PLANNING AND DEVELOPMENT SERVICES

DATE: June 23, 2021
APPLICATION: PRDP20211477

SUBJECT: Industrial (Light) / Discretionary use, with Variances

APPLICATION: Industrial (Light), construction of four (4) multi-bay commercial buildings, tenancy, and signage, and relaxation of the minimum tree/shrub requirement

Building #1 Elevations

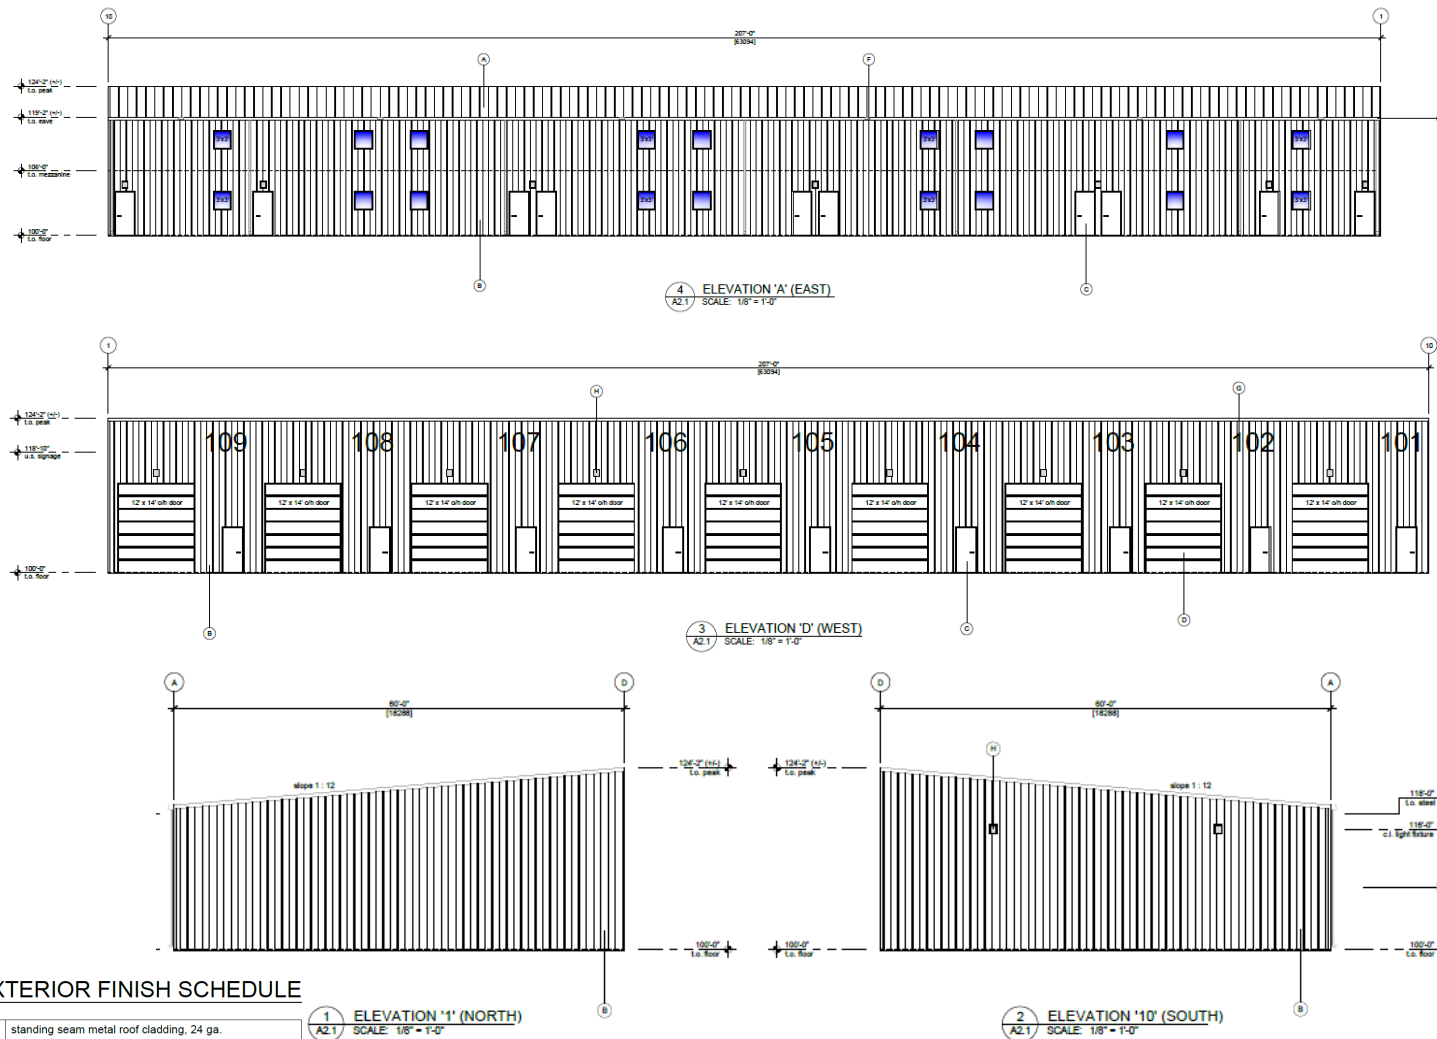
4. That prior to release of this permit, the Applicant/Owner shall submit revised elevation drawings, to the satisfaction of the County, that addresses the following:

- i. The exterior colours, materials, and finishes of all buildings shall be coordinated to achieve a reasonable continuity of appearance, in accordance with Appendix B of the Janet ASP;

- ii. The facades of buildings that exceed 30.00 m (98.42 ft.) measured horizontally and facing roadways (west façade of building #1), shall incorporate wall plane projections or recesses having a depth of at least three (3) percent of the length of the façade and

extending at least 20 percent of the length of the façade, in accordance with Appendix B of the Janet ASP;

- iii. That every bay of each building shall have a clearly defined main entrance featuring at least two of the following: canopy or portico; overhang or arcade; raised corniced parapet over the door; outdoor amenity area; upgraded window glazing areas; or integrated planters or landscaped sitting areas, in accordance with Appendix B of the Janet ASP.
